## Committee of the Whole Report

### For the Meeting of November 18, 2021

**Subject:** Rezoning Application No.00710 for 1905 Lee Avenue

SITE PLAN

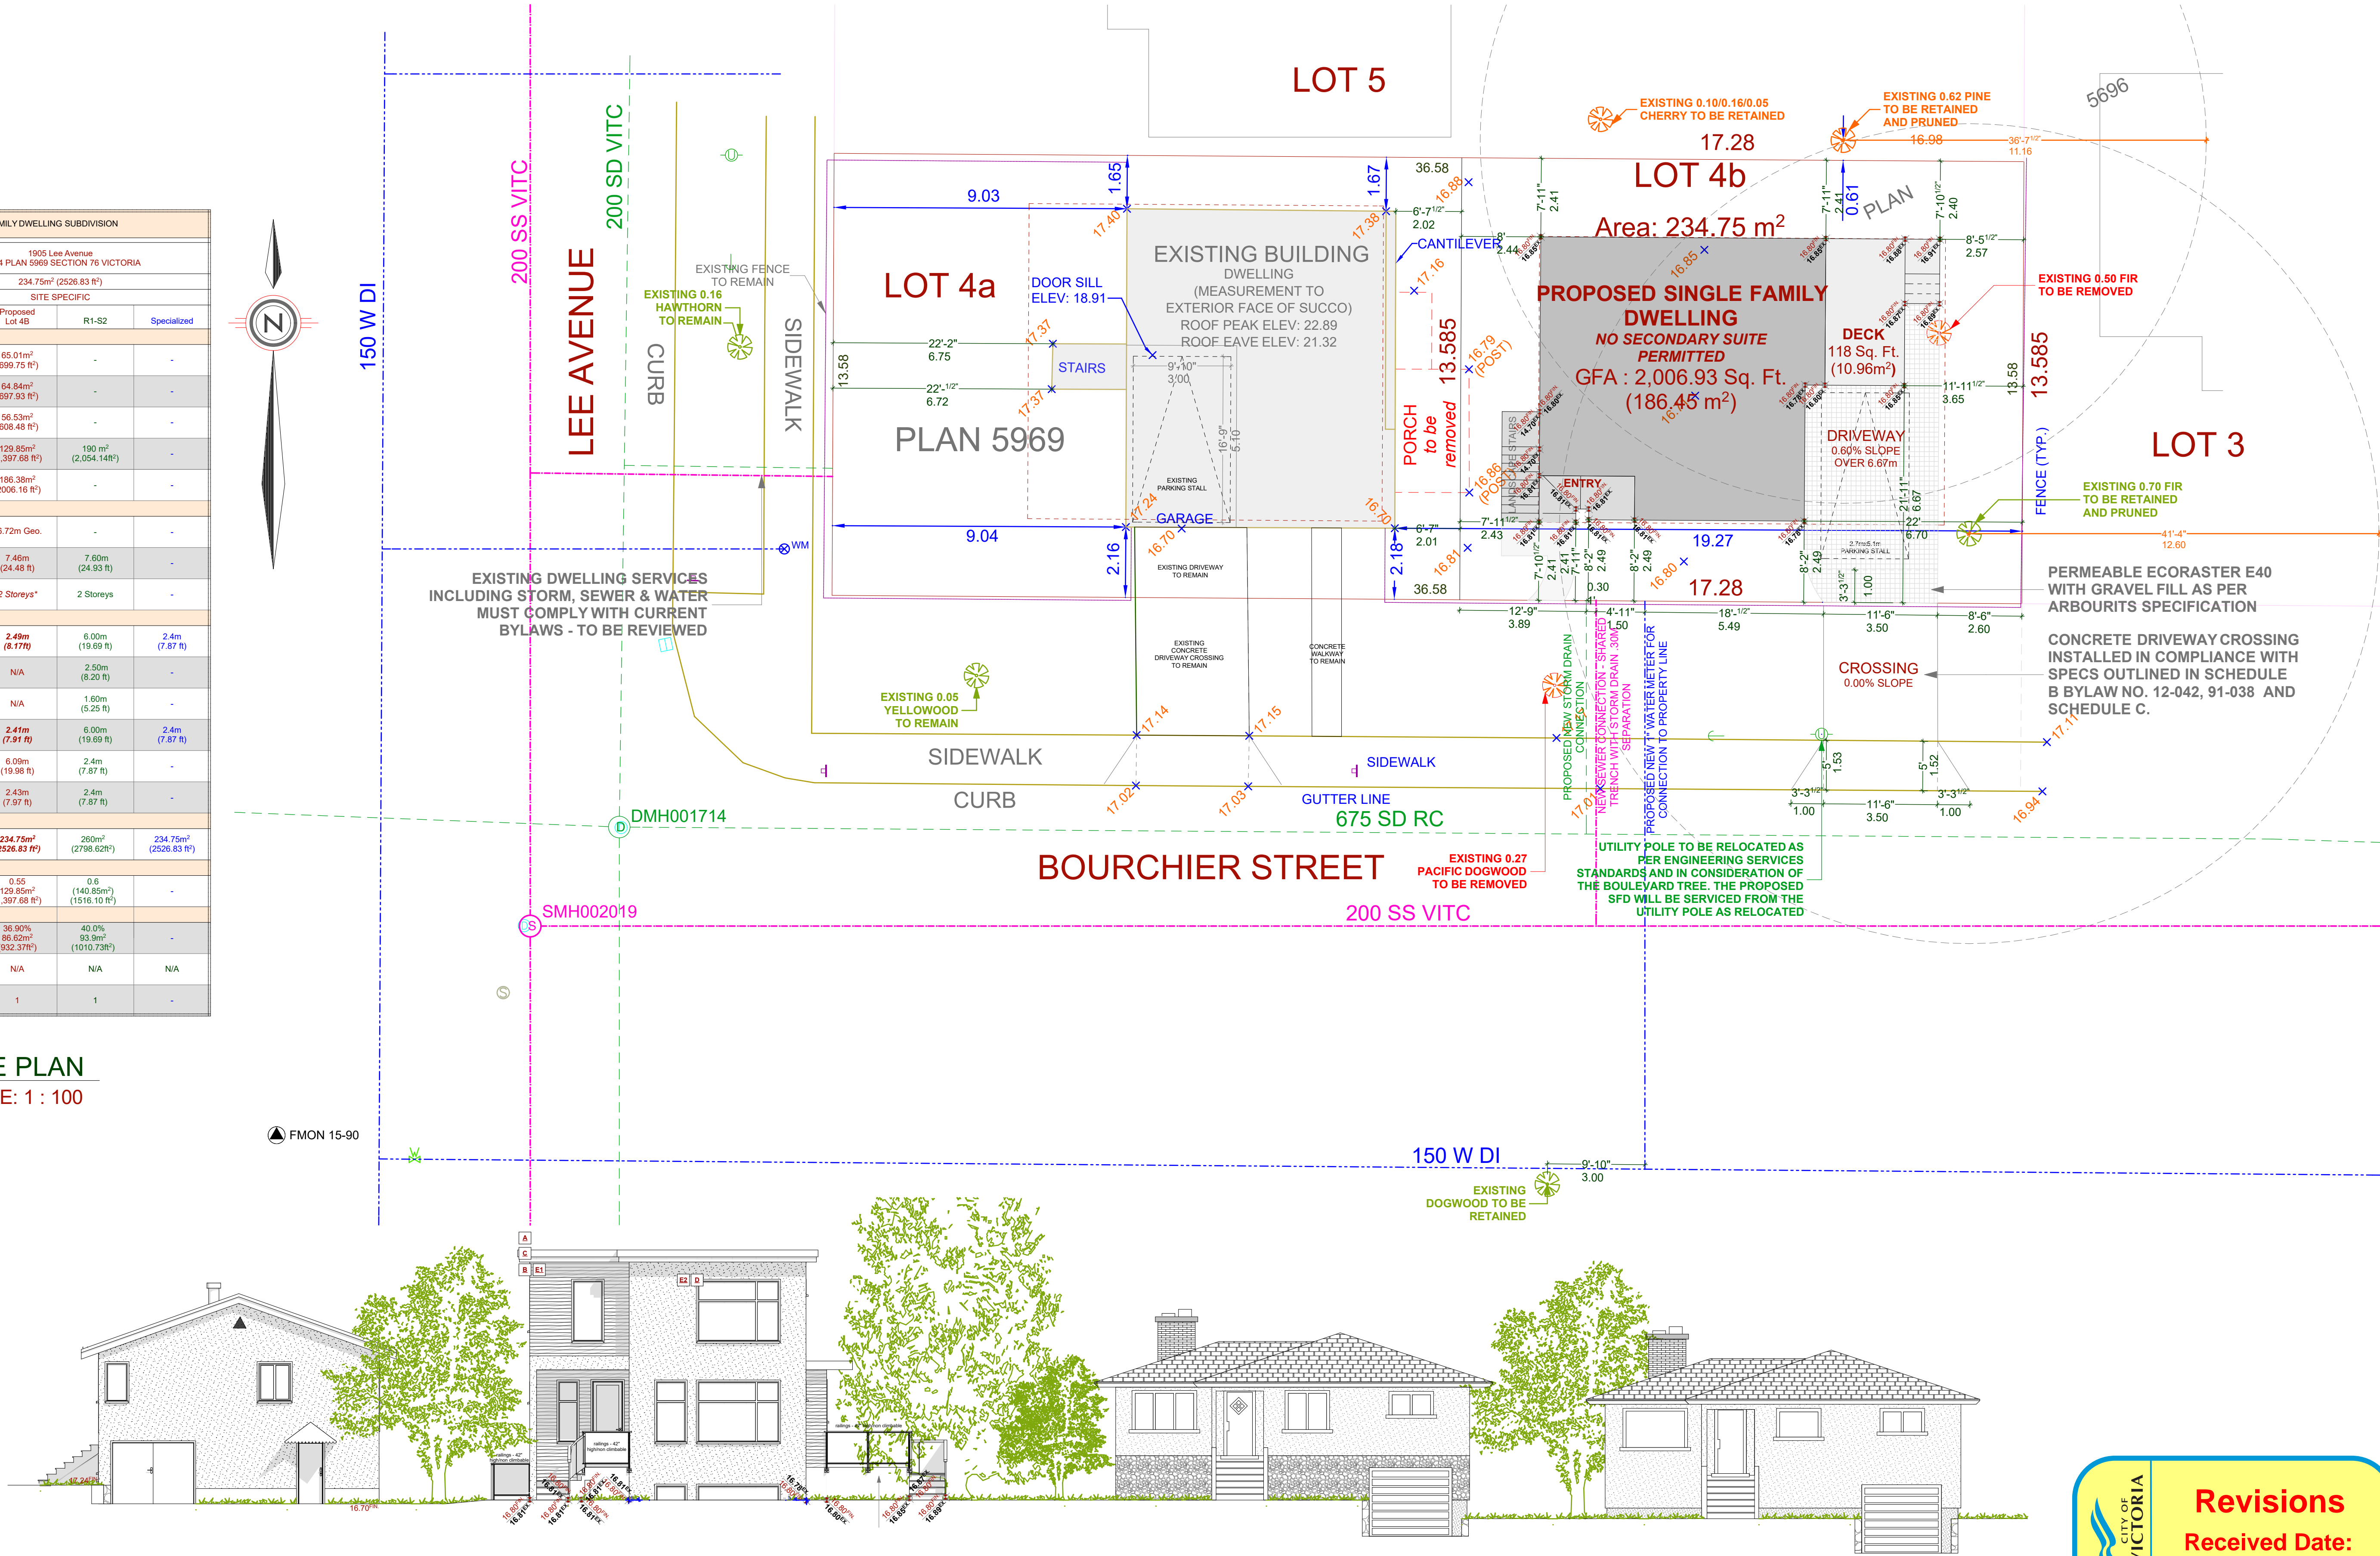
- The new house requires variances to reduce the front and rear yard setbacks. The reduced lot area creates challenges with overall site planning and results in a smaller rear yard which limits the availability of private outdoor space and creates shadow impacts on the property to the north. The front yard setback is generally in line with the side yard setback of the existing house, but it sits in front of the neighbouring houses to the east.

The reduced lot area creates challenges with overall site planning and results in a smaller rear yard which limits the availability of private outdoor space and creates shadow impacts on the property to the north. The design guidelines say a reduced rear yard is acceptable if careful attention is paid to privacy and shadowing. The proposed house is two-stories, with no building articulation or upper-level step back, and it has two bedroom windows on the second storey. There are two trees on the neighbour's property which offers some visual screening, however, the design guidelines recommend implementing design solutions rather than using landscaping (which may be removed in the future) to address potential impacts. Design revisions are recommended, such as stepping back the second storey. A shadow study was requested, but the applicant declined to provide one.

- Need better representation of proposed development in context to other houses/properties on the street. Include a site plan that includes adjacent properties and panoramic street profile.

- i. Step back the second storey on the north elevation
- ii. Reduce potential privacy impacts from bedroom windows
- iii. Provide landscaping around the above grade deck
- iv. Identify materials of pathway to house
- v. Show basement window wells on plans, and revise landscape plan to reflect this change
- vi. Make the entry more prominent by having an overhang

- vii. Show the proposed location of the utility pole, and that the pole relocation has been approved. Proposed location must comply with the Highway Access Bylaw and not impact existing trees or impede future planting of boulevard trees.

DRAWING NAME: EXISTING DWELLING FLOOR PLANS, ELEVATIONS AND SEPARATION CALCULATIONS  
DRAWING SCALE: 1/4"=1'-0"

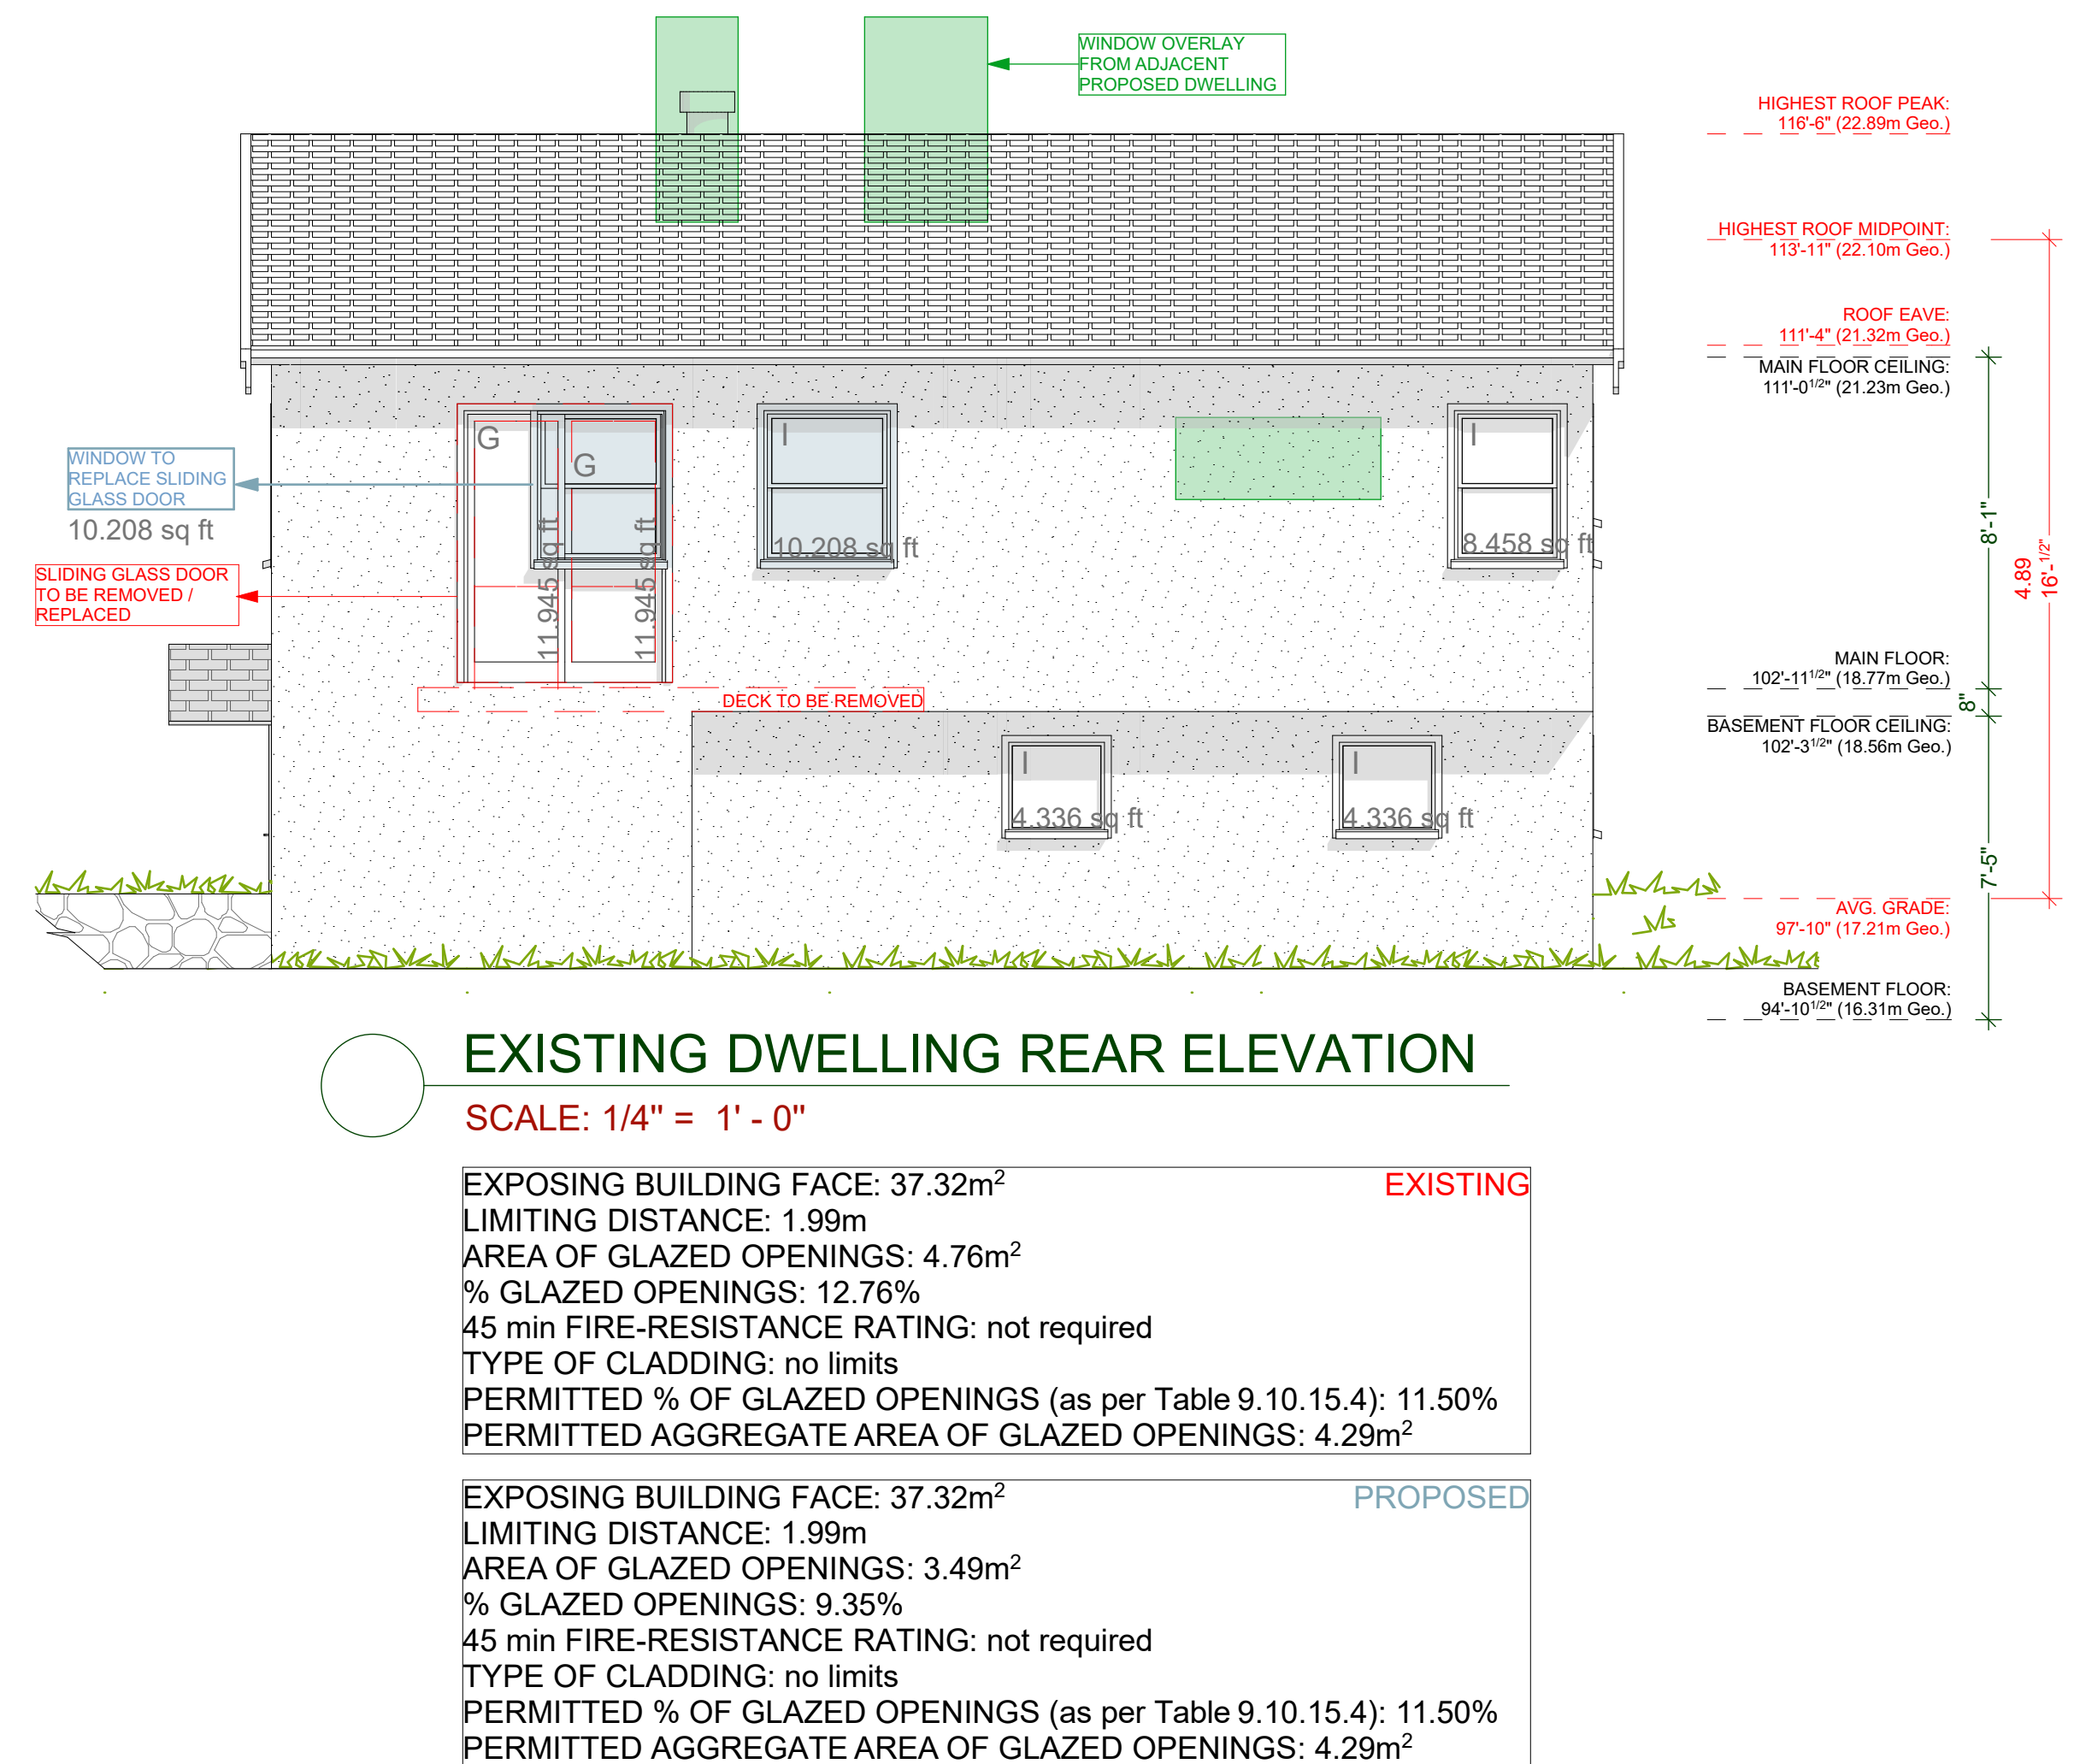
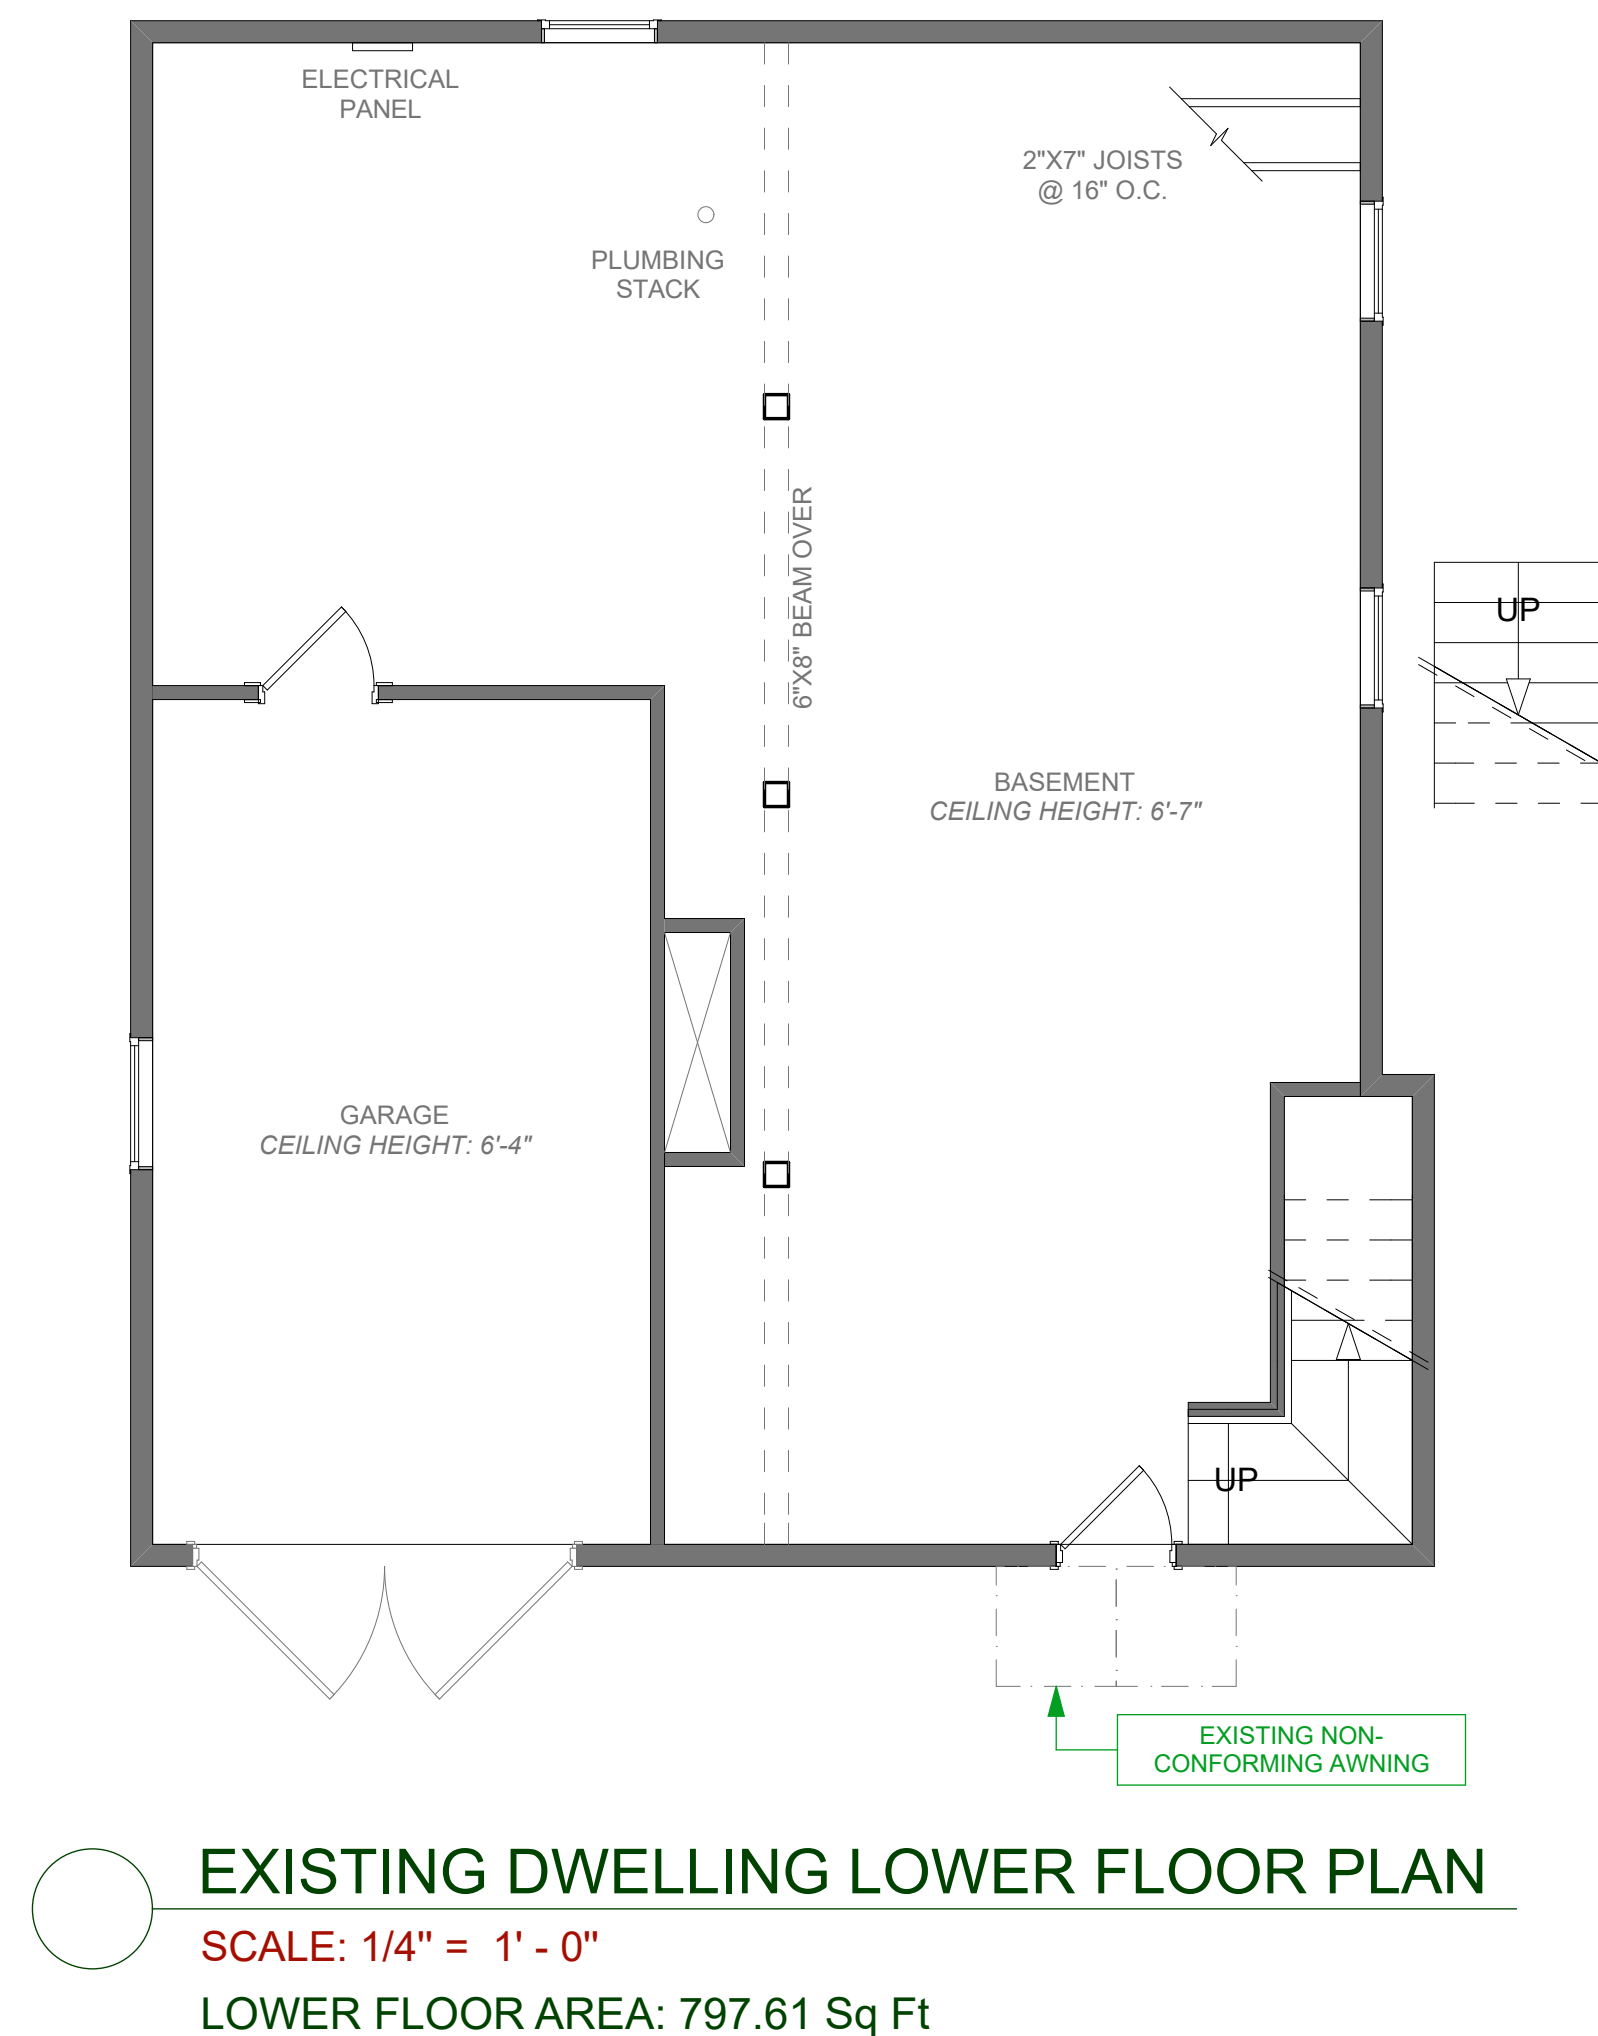
- The variances associated with the existing house are to reduce the rear and north side yard setback. The side yard setback is not actually changing but a variance is triggered because the regulations in the R1-S2 Zone require greater setbacks to habitable windows than the current zoning. Since there is no actual change proposed, it is considered supportable. The reduced rear yard setback results in a rear yard which would be just over two metres deep and does not create a usable outdoor space for residents.

- i. Provide a usable outdoor space for the existing house
3. Once design revisions are made, discuss plans and re-petition immediate neighbours as per the Small Lot Policy.
